Tamworth Solar Farm

Response to Request for
Information 29/4/20

Prepared for: Tamworth Solar Farm Pty Ltd
May 2020

This document contains Tamworth Solar Farm's response to a request for additional information from the Department of Planning, Industry and Environment dated 14th April 2020 as well as additional requests on the 4th, 7th and 12th of May.

Figure 2. Site entrance points.

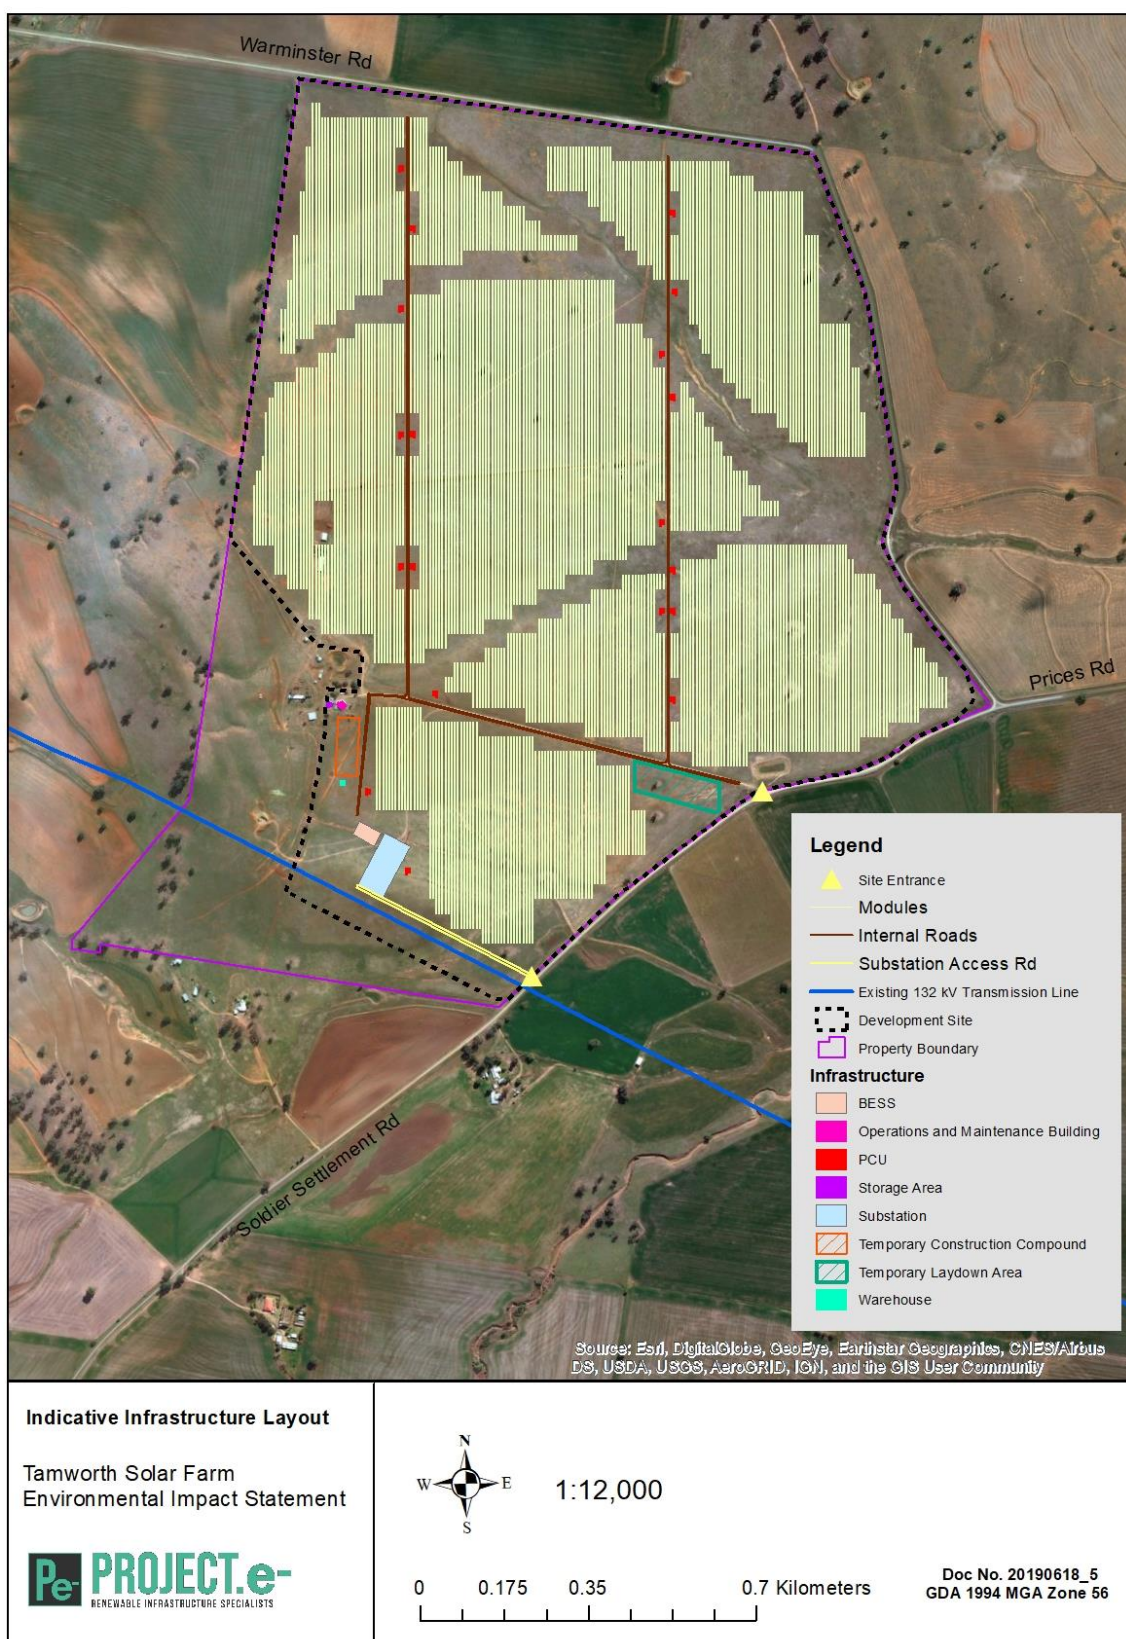
Requested Information: *“Clarify the number and location of site access points to the site.”*

There are two site access points as shown in Figure 2. The most northern access point is the main access point to the site. The southern access point is to the substation and will be used infrequently.

Appendix A. Oxley Highway / Babbinboon Rd intersection concept plan and swept path diagram

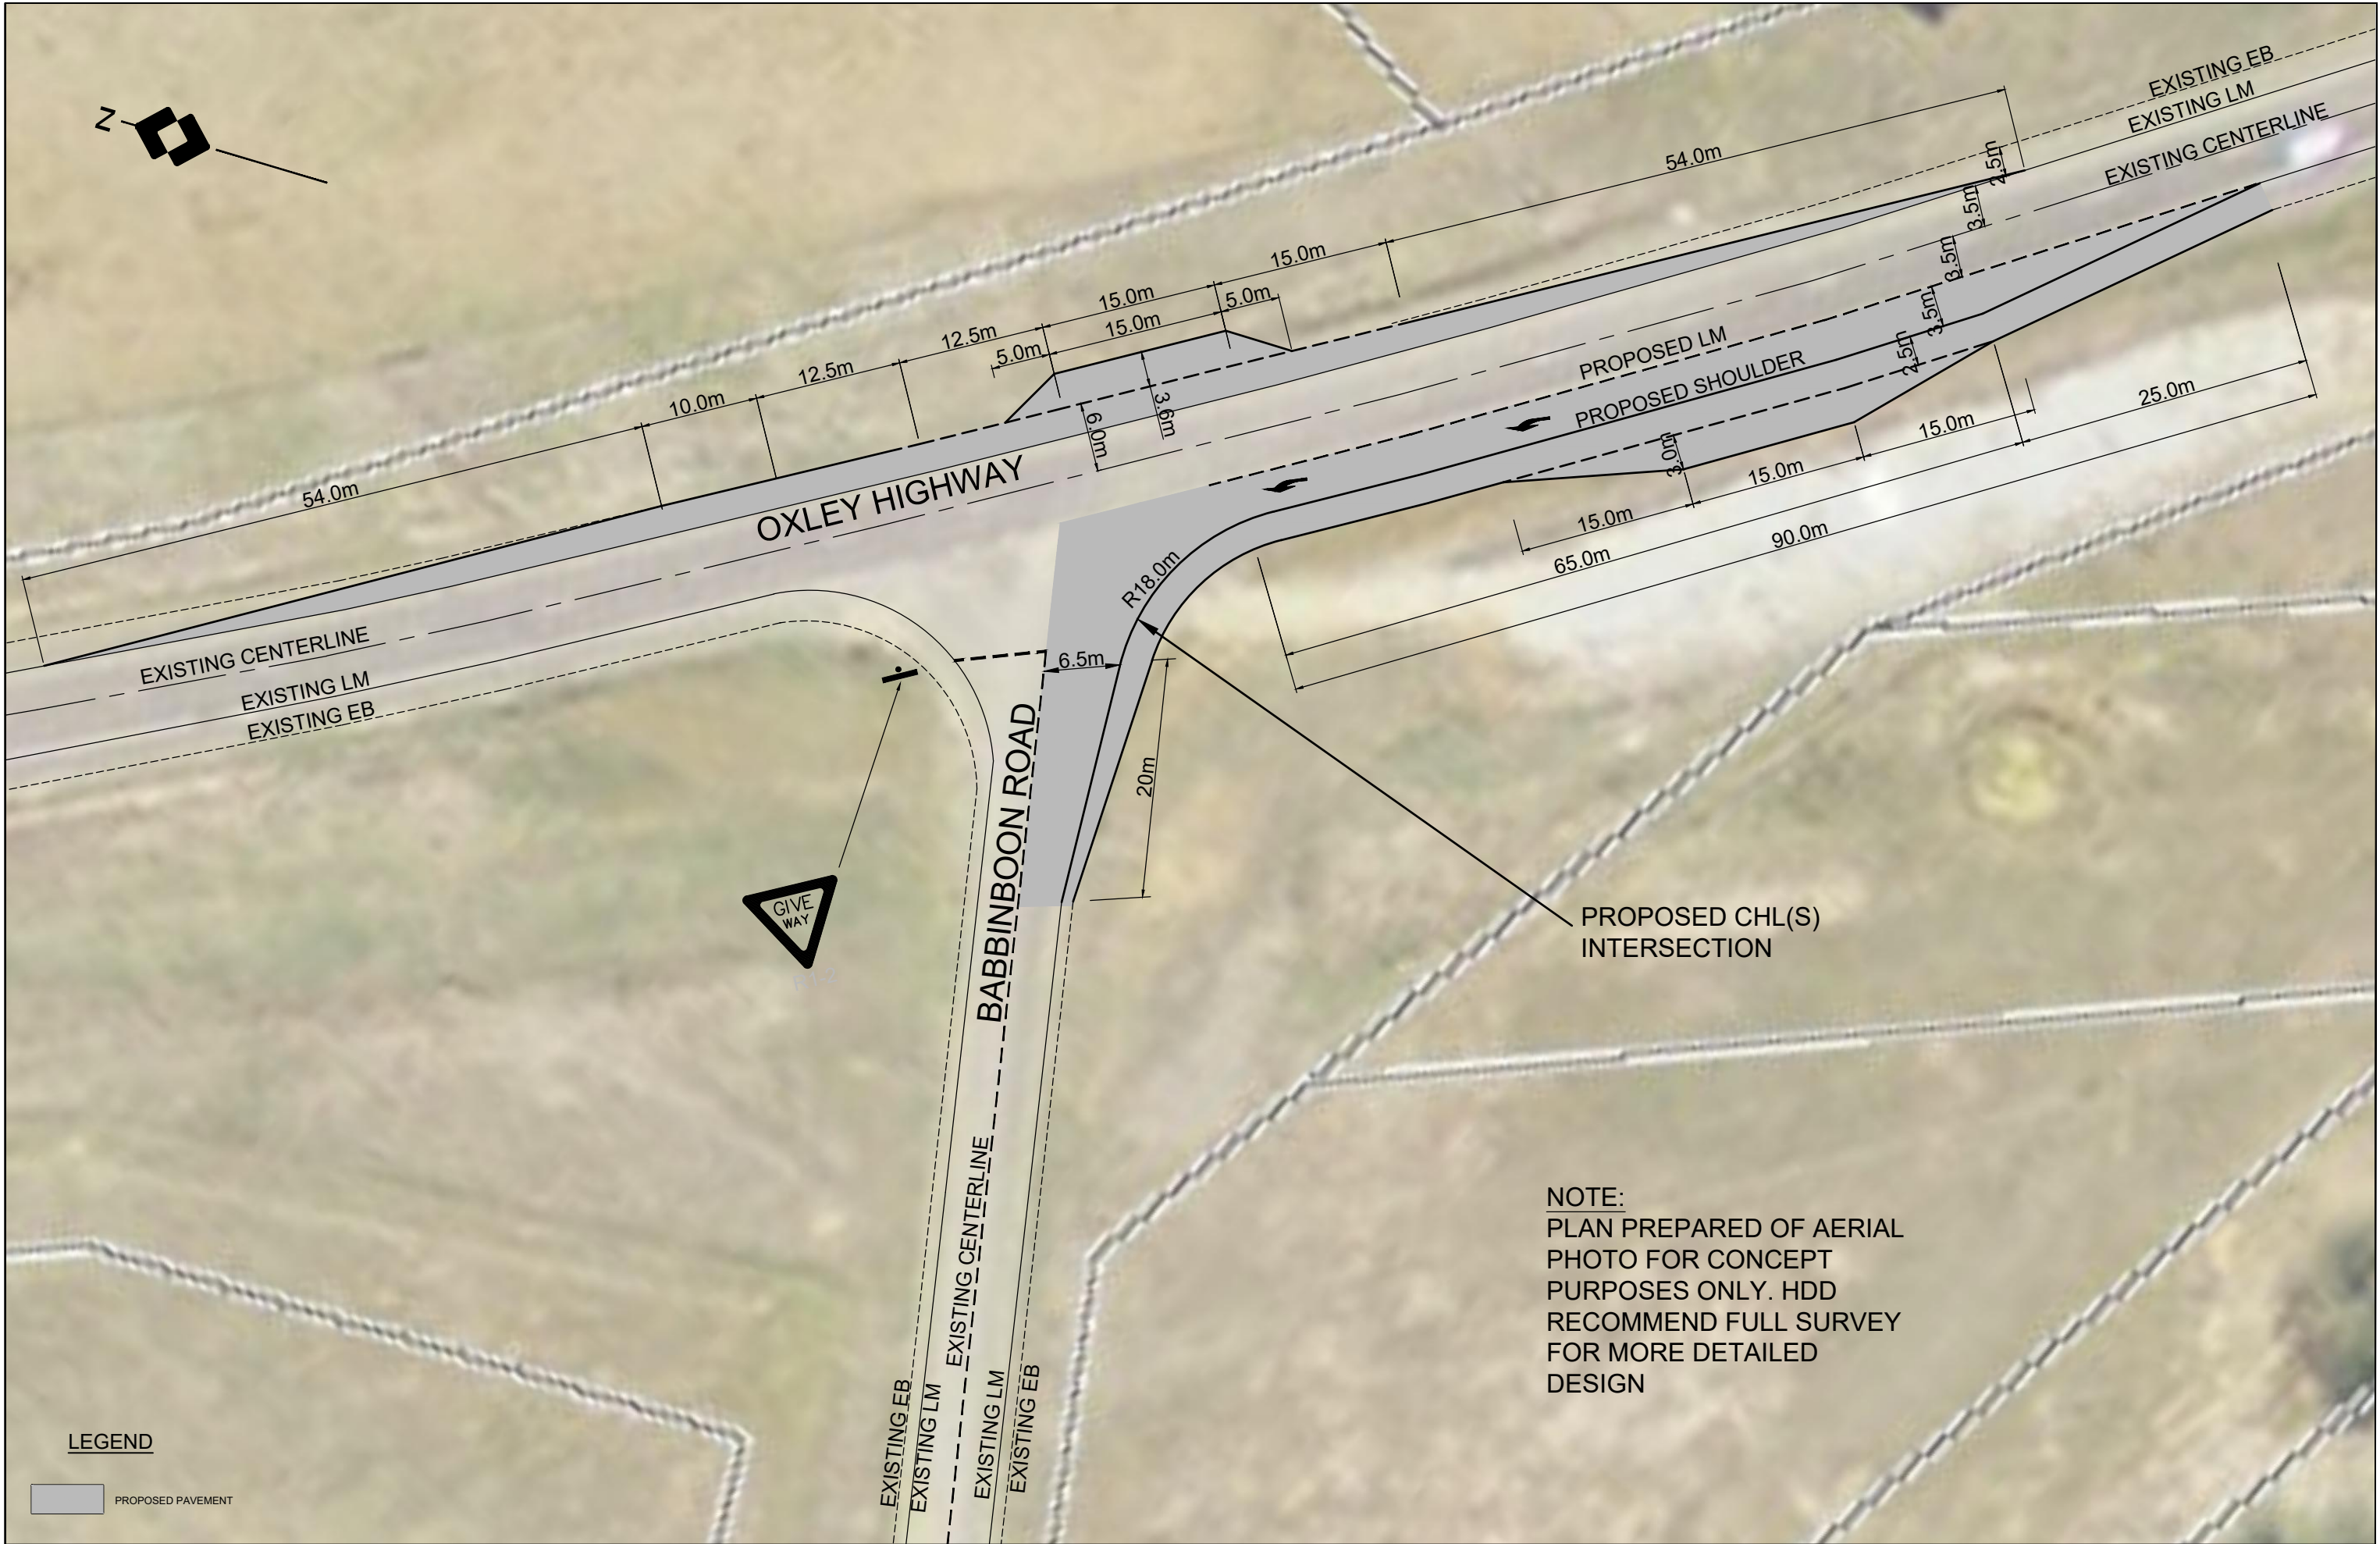
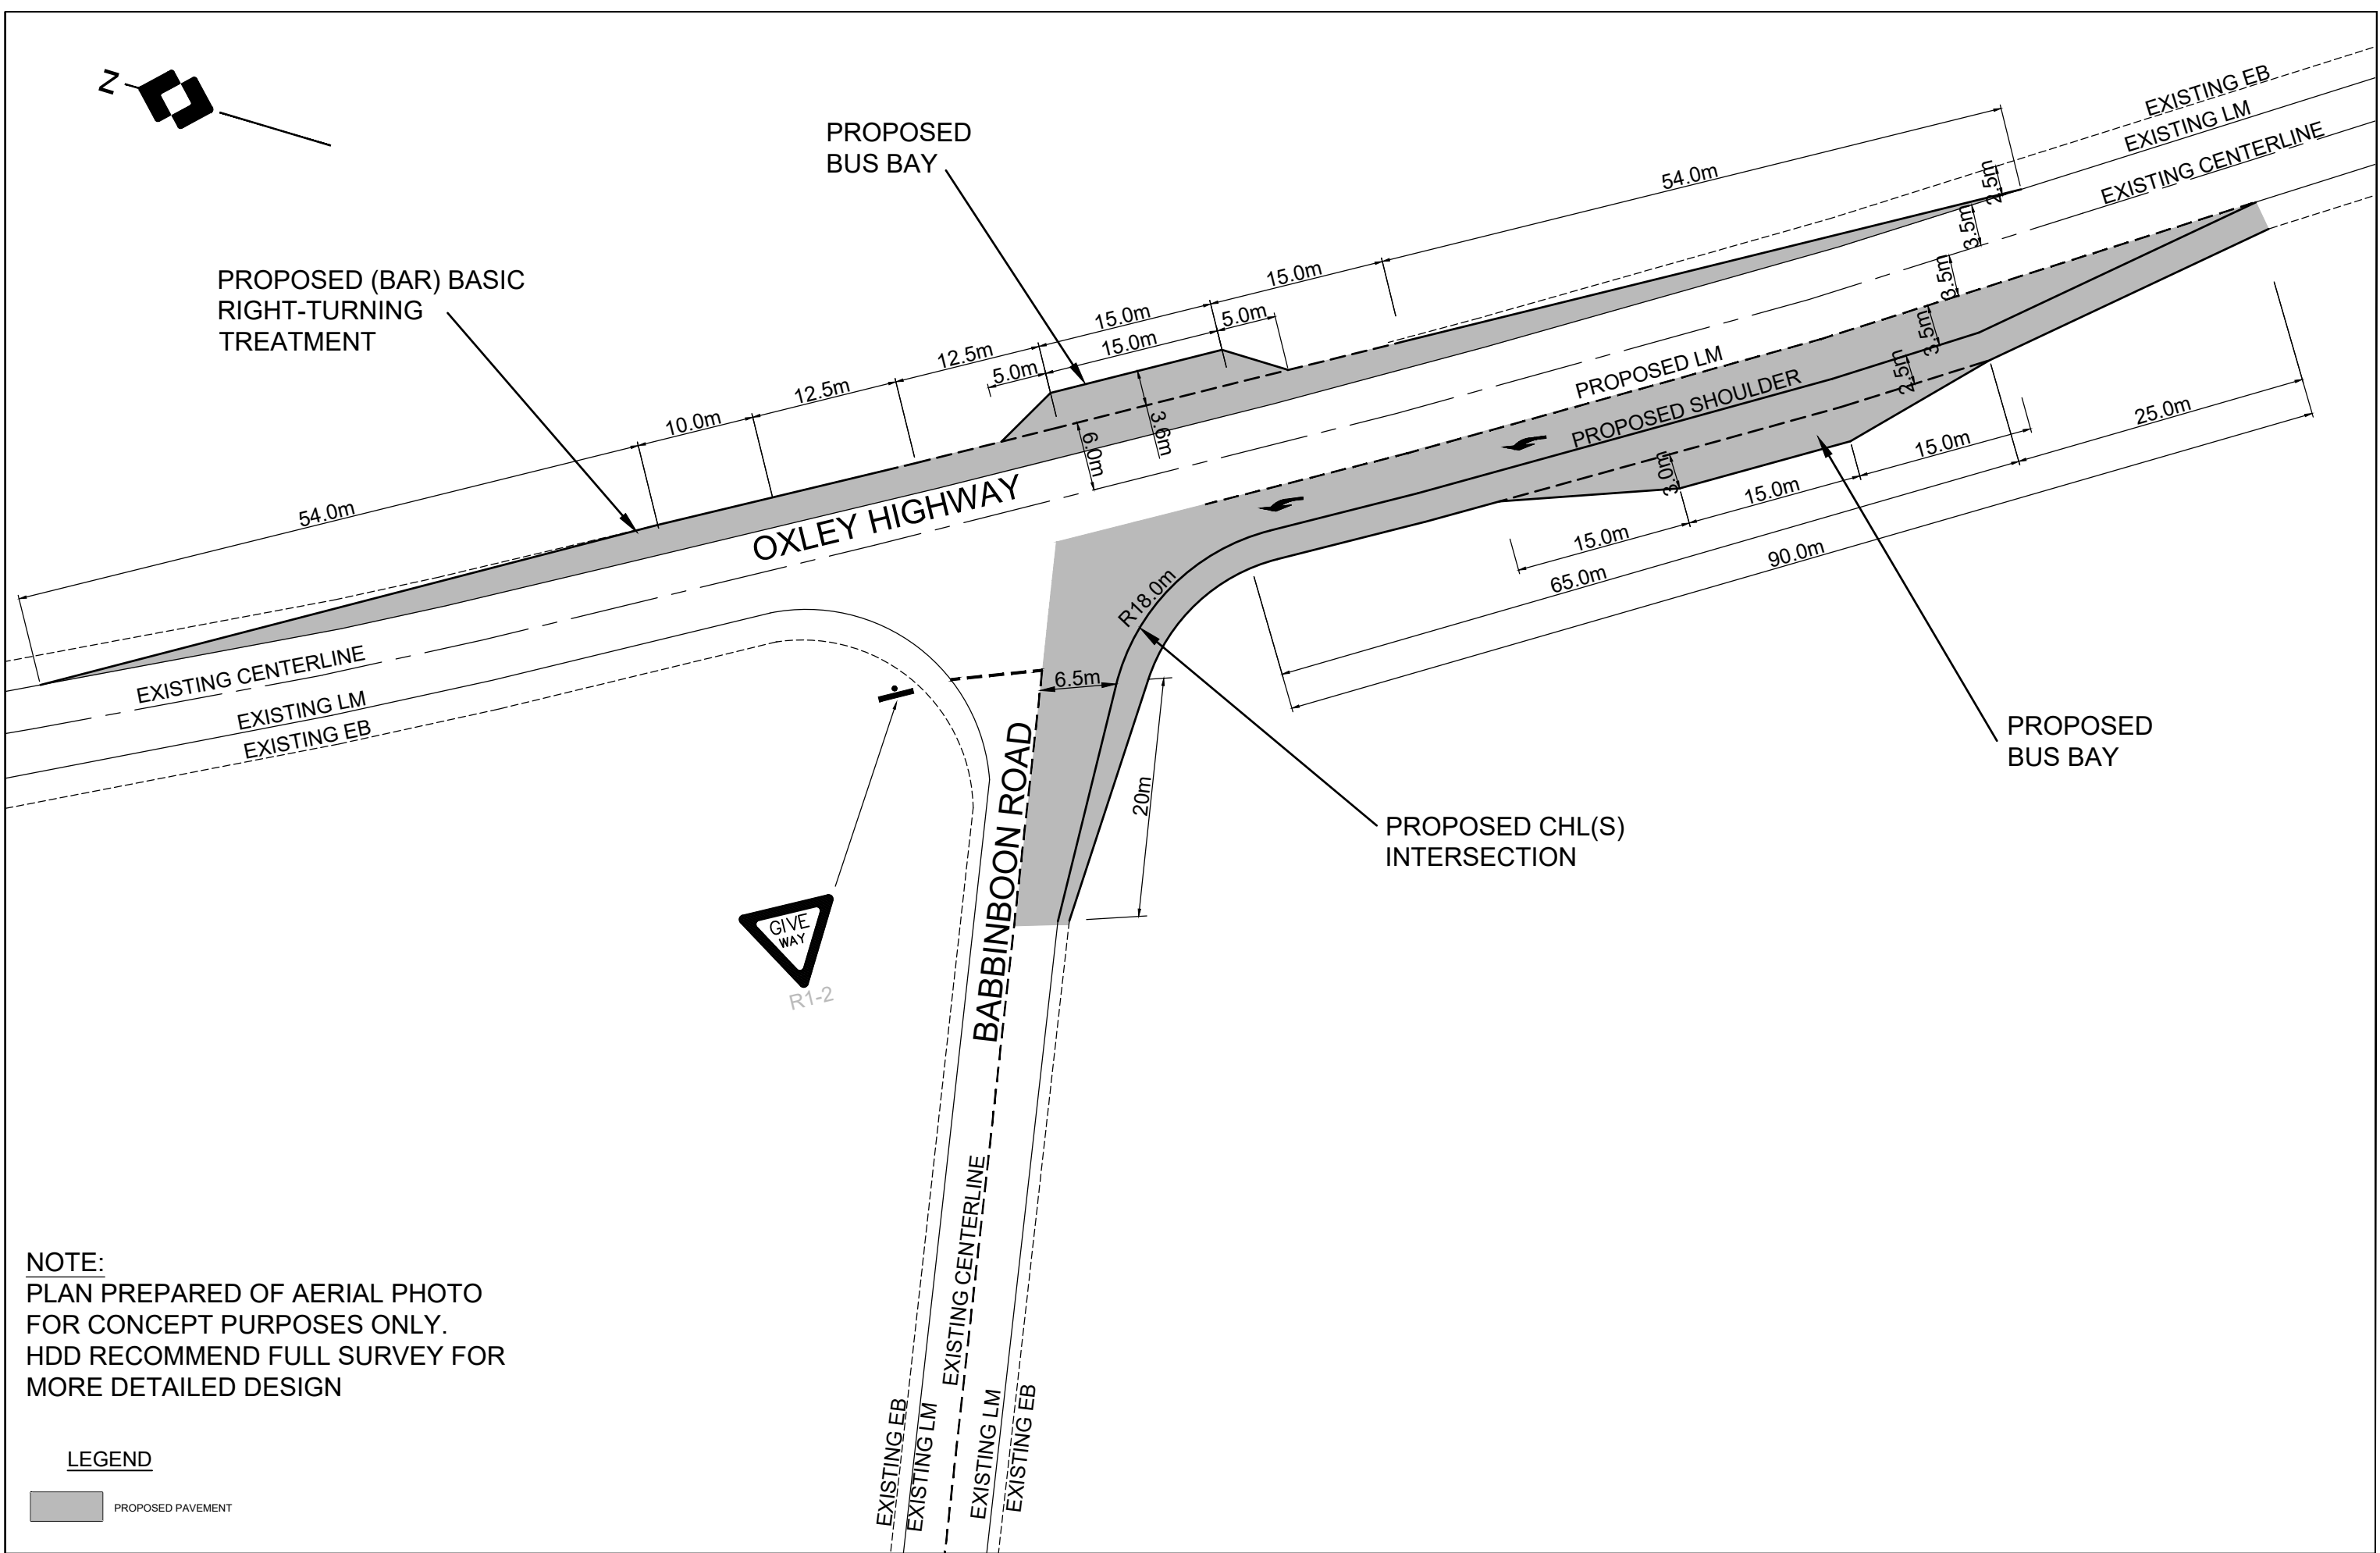
Requested Information: *"Clarify the nature and location(s) of the intersection upgrades and intersection treatment types and include a swept path diagram for the largest vehicles travelling to and from the site."*

The intersection of the Oxley Highway and Babbinboon Road is being upgraded to include a deceleration lane for vehicles turning left into Babbinboon Rd. Based on the discussions with TfNSW and on their request, a Basic Auxiliary Right (BAR) treatment is being provided at the intersection. Furthermore, two new bus stops will be provided that will give a much greater level of safety than the existing bus stops. A concept plan for the upgrade and a swept path diagram for the largest vehicle is included as Appendix A. Further information on why a higher level of treatment is not required is provided in the Technical Design Note in Appendix F along with information on sight lines for the bus stops.

To provide better bus stop locations at the intersections, Tamworth solar farm will construct sealed bus stops as shown in Appendix A. These locations have been discussed with Macphersons Coaches and they think the sites are suitable. An email from Macphersons is provided in Appendix C. The request they made to have the bus stop on the northern side of the highway widened to 3.6m has been included in the concept design in Appendix A.
